Certificate of Appropriateness

Re-issue/Amended

Property 1851 N. 2ND ST. **Brewers Hill Historic District**
Description of work Re-build front porch deck and roof. Retain historic carved column capitals for re-use on re-built porch. Re-build porch to match original using clear, knot-free finish lumber. Where column capital portions are missing, new pieces will be re-cast in a synthetic material. Spot replace wooden clapboard where missing or damaged with new, matching genuine wood clapboards that are smooth and knot-free.

Date issued 10/3/2014 **PTS ID** 84876 **COA, front porch re-build--reissue/amended**

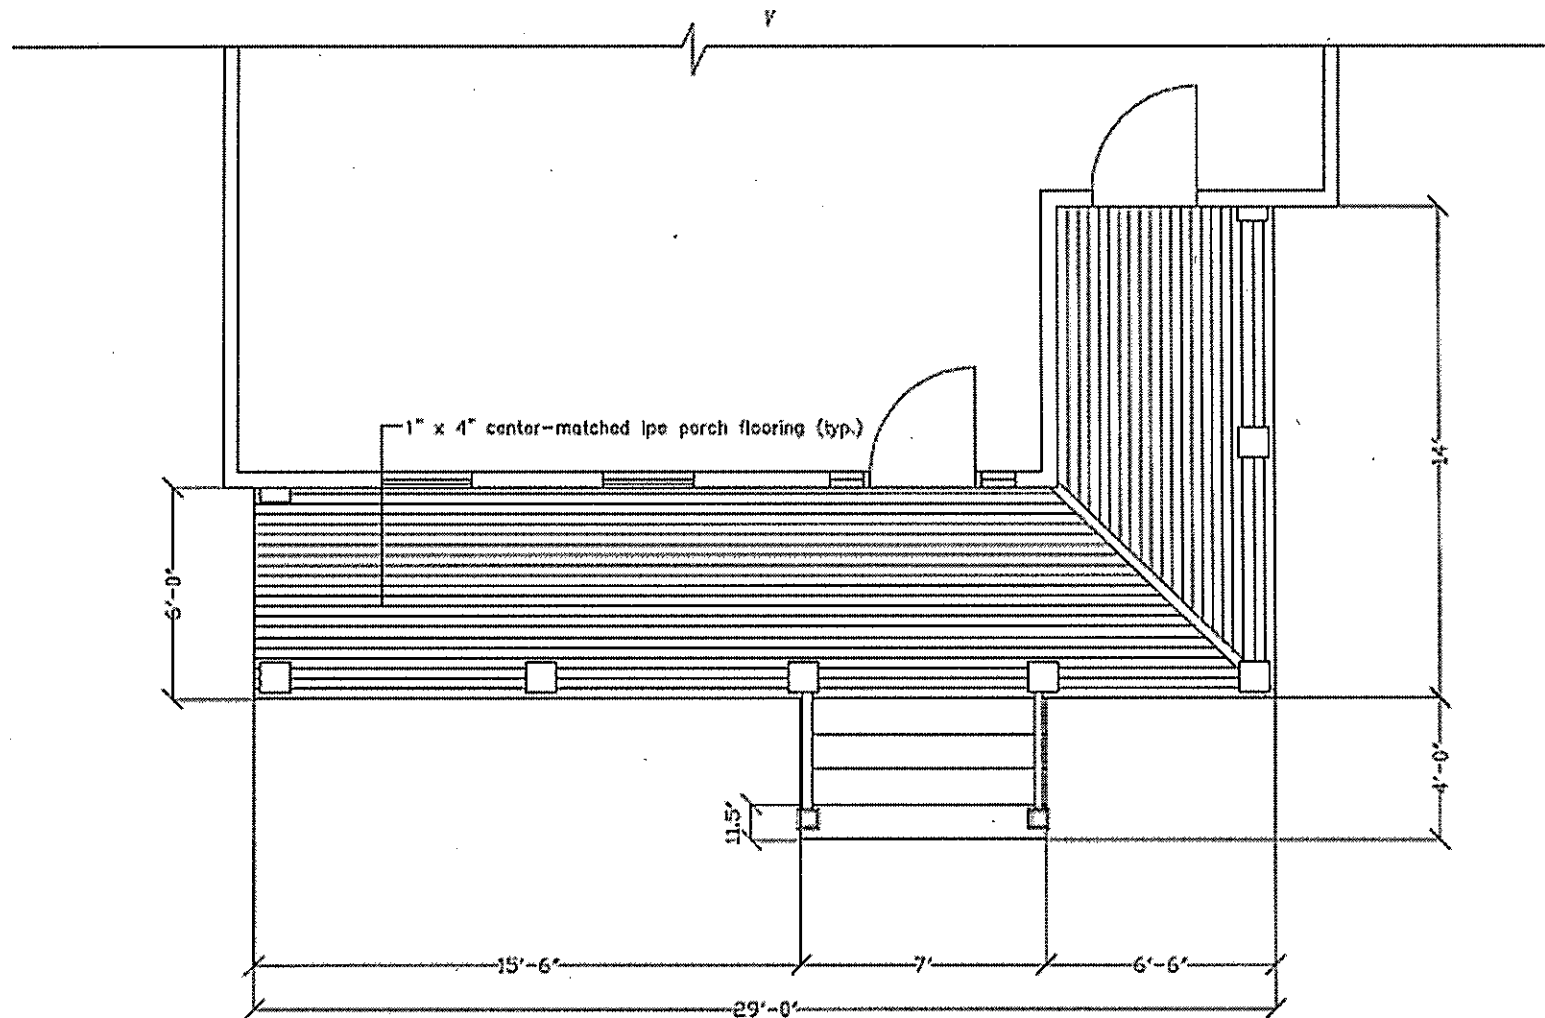
Current photo (10/3/14) of house showing partially rebuilt porch with extensive deterioration to fascia, soffit, ceiling and roof decking. Previous attempt to rebuild porch utilized common pine boards with knots. This must be replaced with clear, knot free material. The finish material on the building now exhibits extensive mold coverage.

All finish material that is unpainted on roof structure must be removed and replaced with clear, knot-free material. Much of the unfinished material in this current photo exhibits a bloom of mold. Column capitals are original and must be saved. Roof sheathing appears to be deteriorated and must be replaced with new material.

Plan of new front porch for 1851 N. 2nd Street

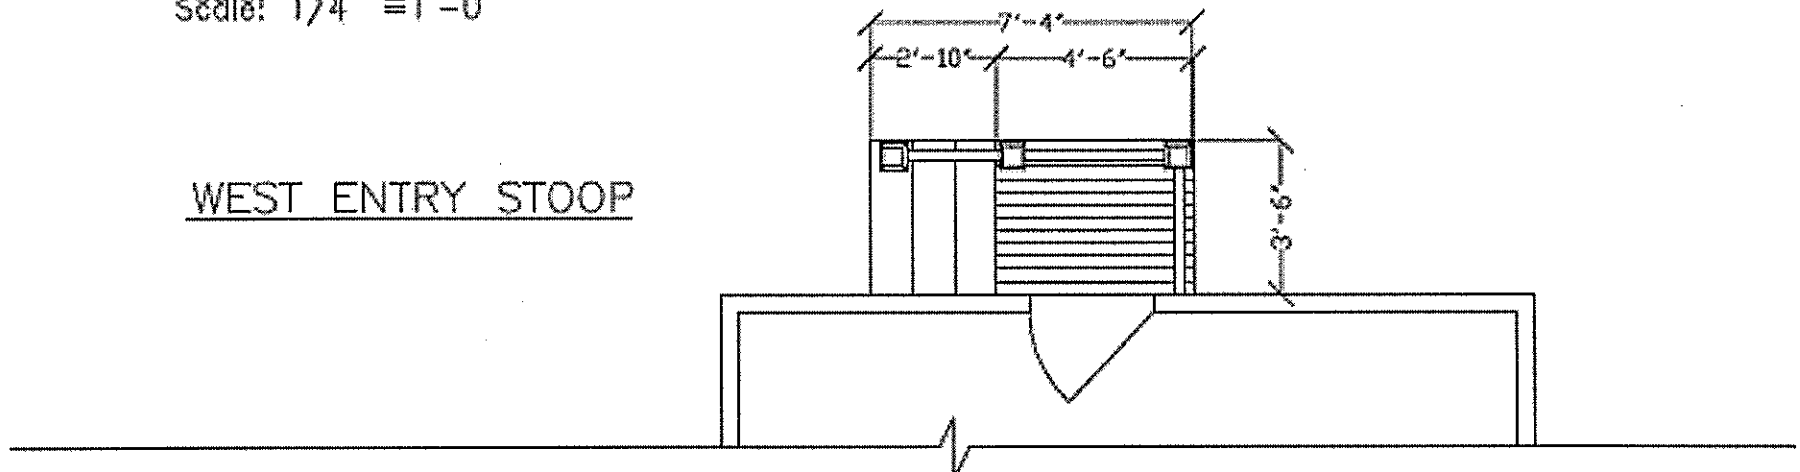
COVERED EAST ENTRY PORCH

WEST ENTRY STOOP

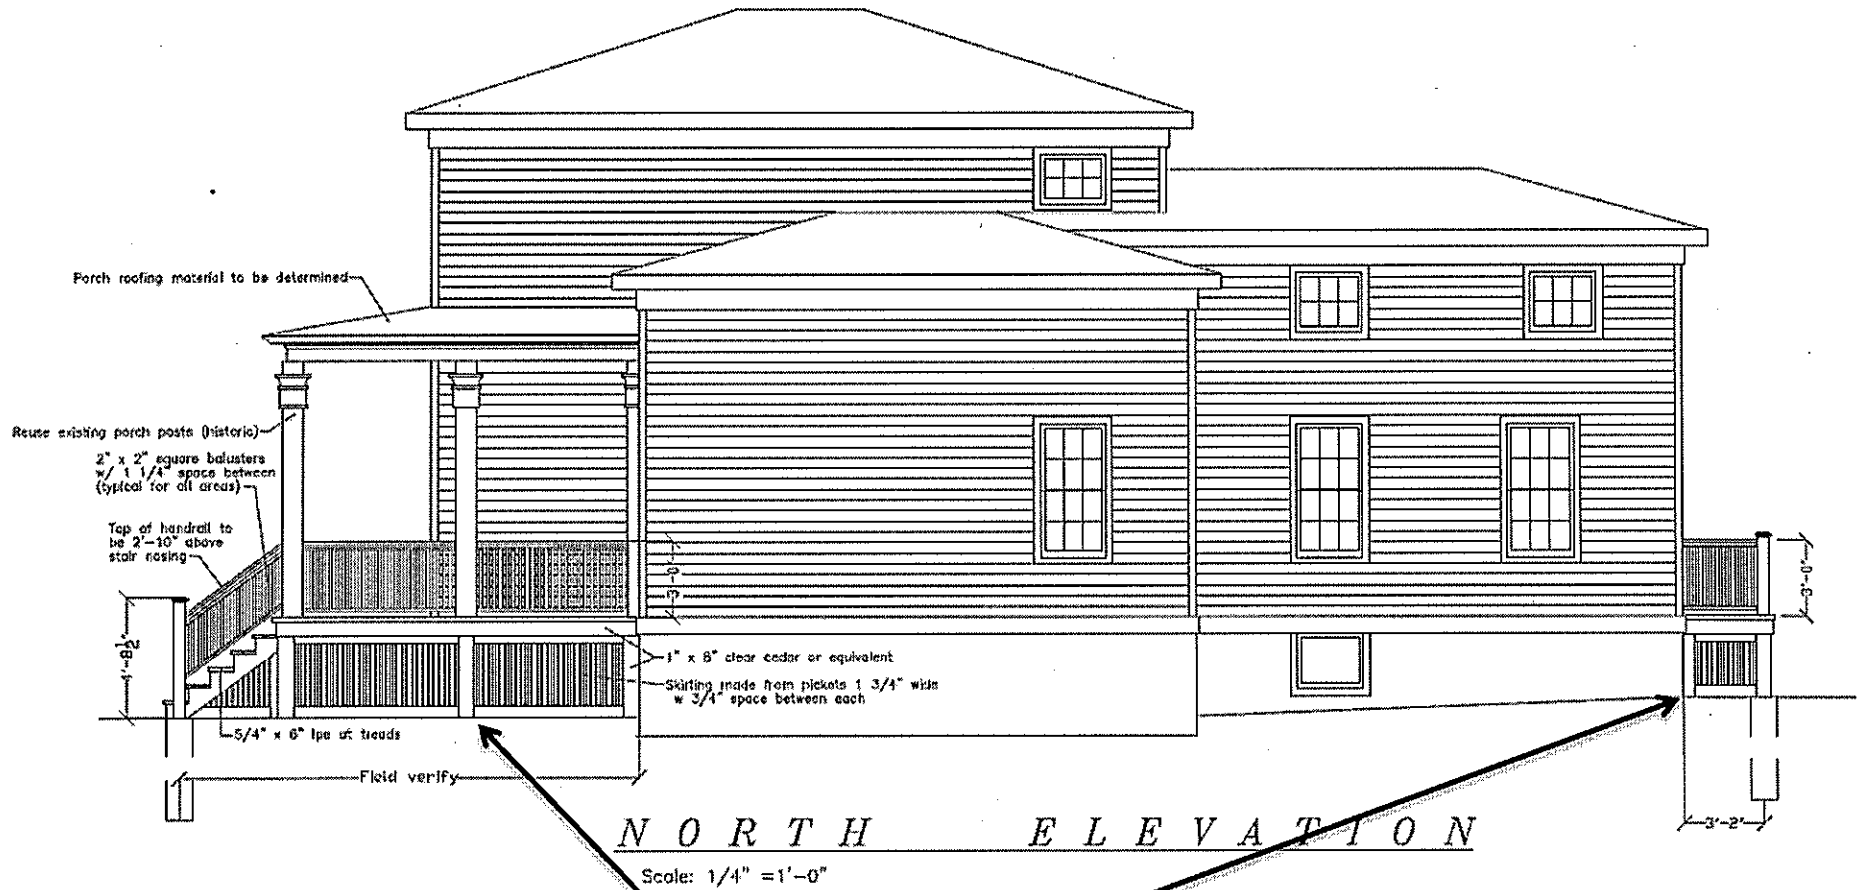
Plan of new back door stoop. Railings and newel posts to match front porch detail included in this COA. Because there is no roof over this porch the decking boards can be gapped 3/16" for water run-off.

W E S T E L E V A T I O N

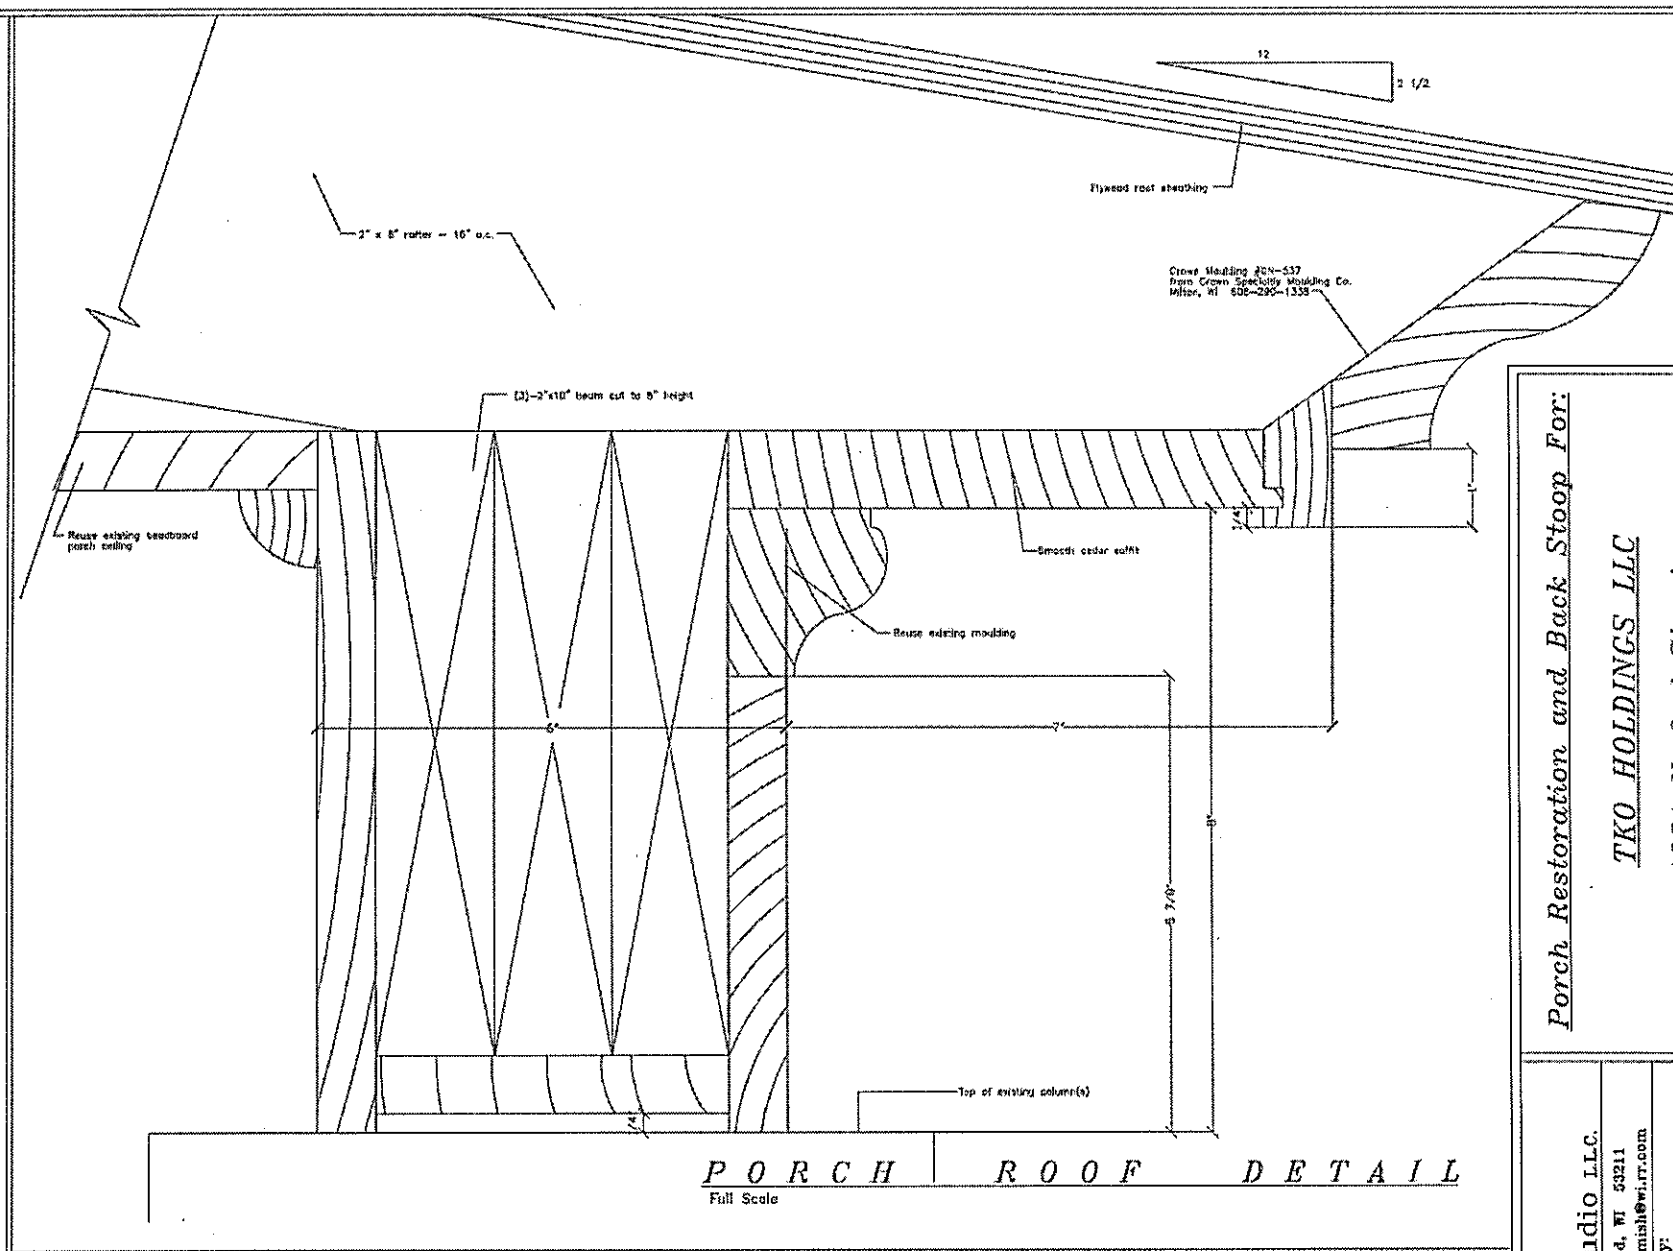
Rear elevation showing new stoop with newels, and skirting and foundation piers that extend 48" below the grade.

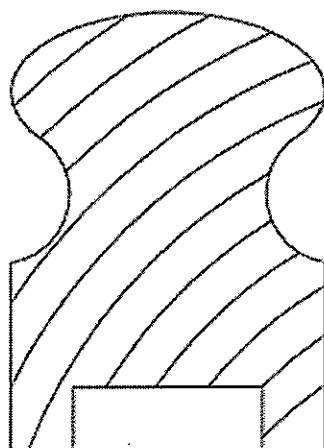
Section drawings of front porch overhang. PLEASE NOTE: Molding on edge of roof must match exactly the profile shown as that is an exact copy of the original.

B O T T O M R A I L

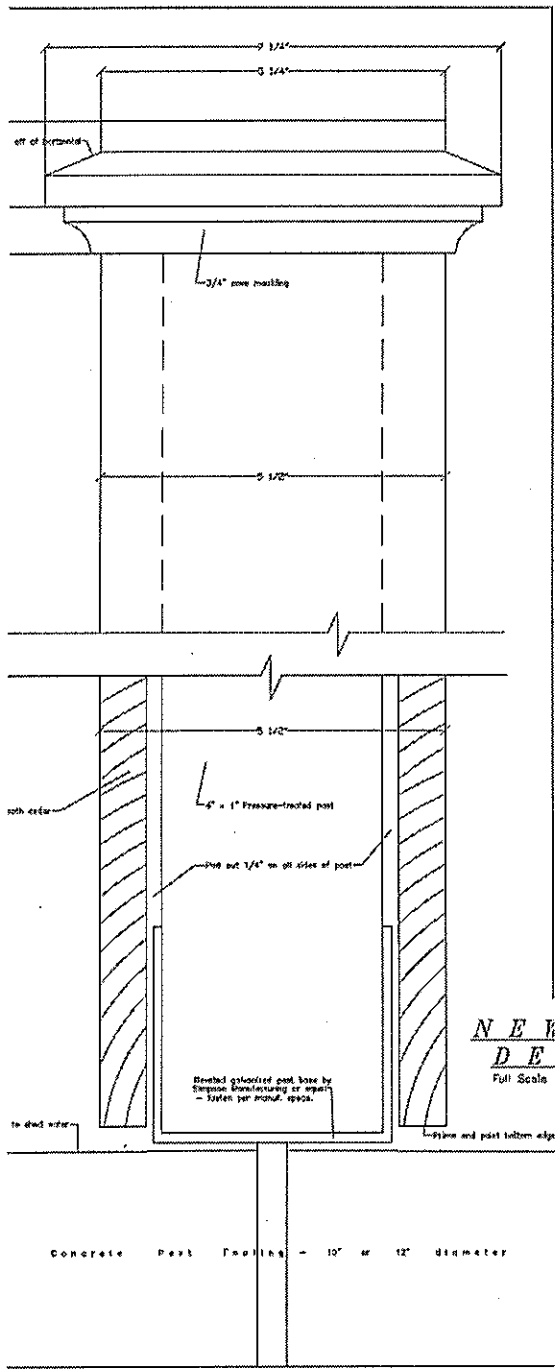
Bottom rail to be site-made
2" x 4" with beveled corners
Bottom piece 3/4" thick with
round-over and fillet edging
Screw together

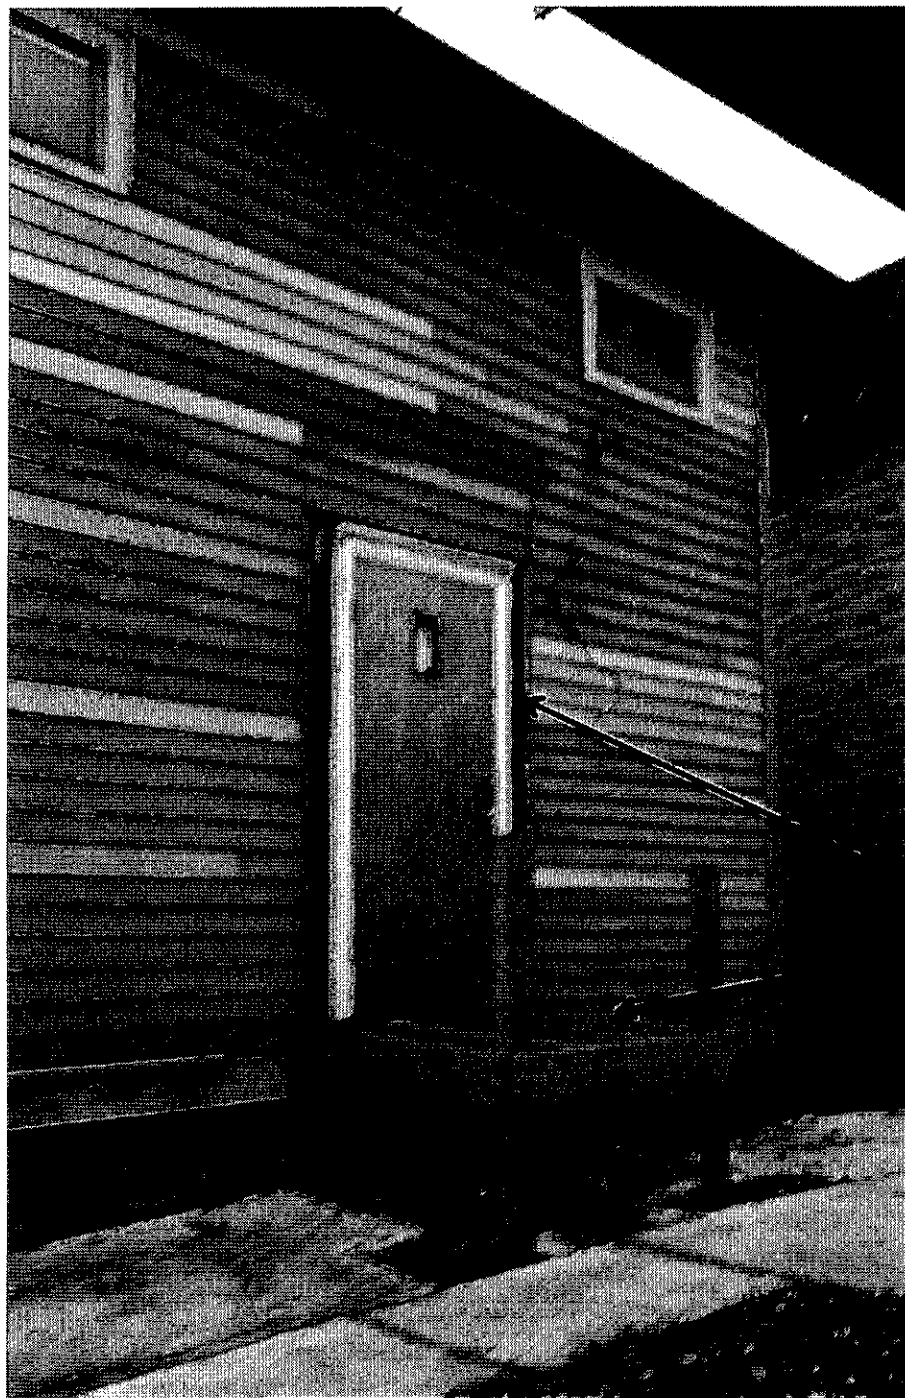
Section of newel posts to be located at the bottom of each side of the front steps.
